UNITED STATES PATENT AND TRADEMARK OFFICE

APPLICATION NO.	FILING DATE	FIRST NAMED INVENTOR	ATTORNEY DOCKET NO.	CONFIRMATION NO.
09/762,473	02/07/2001	Ofer Du-Nour	1639/14	4653

Office Action Summary

Office Action

FIG. 3

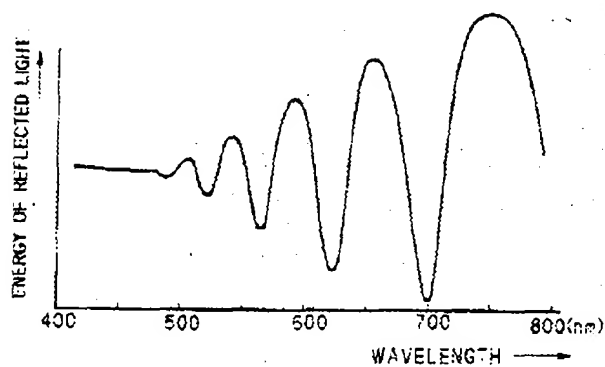
Kondo teaches an apparatus for measuring film thickness comprising a broadband light source(10) for illuminating a film, imaging optics(18), film(S), spectroscopic unit(32) which detects the intensity of the light reflected from the film(figure 4) and produces a signal defining the intensity variations(figure 3), and processor(34) which determines the thickness of the film based on the different frequencies of the signal. See figure 6.

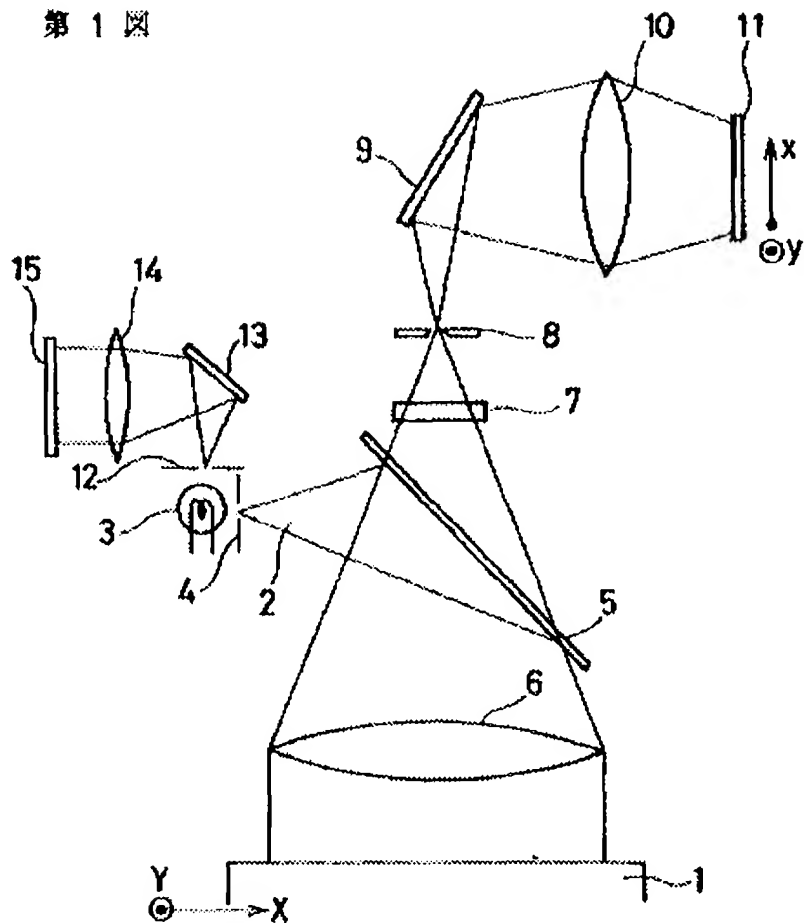
Masayuki et al teaches an alterative spectroscopic analyzer which includes a stationary grating(9), and an array of detectors(11) which provides a detector for each frequency.
